Publishing date	07/11/2019
Document number	SUPAIR_2019_10_002_EN
Page number	1/1

SUBJECT : ACRO 4 Harness : Stitching Flaw

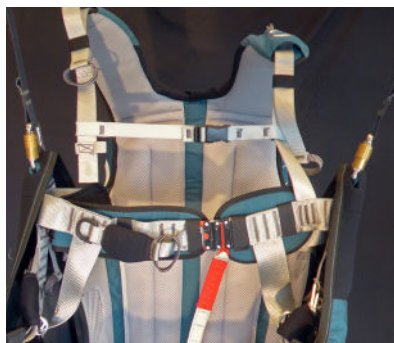
We have identified a problem at one of our client outlets wherein we found a harness missing safety stitching on a ACRO 4 harness produced in March 2019. One of the shoulder webbings was not correctly sewn with the ventral cross strap, but only pre-glued before the automatic manufacturing phase.

We are asking pilots using the ACRO 4 to verify that their shoulder straps are well sewn to the ventral straps (and not merely glued). Check for automatic vertical stitching (3 stitches) to the ventral strap.

The 3 automatic vertical stitching are missing

DO NOT FLY!
Please contact
sav@supair.com
Do not use the harness until properly checked

The 3 automatic vertical stitching are there
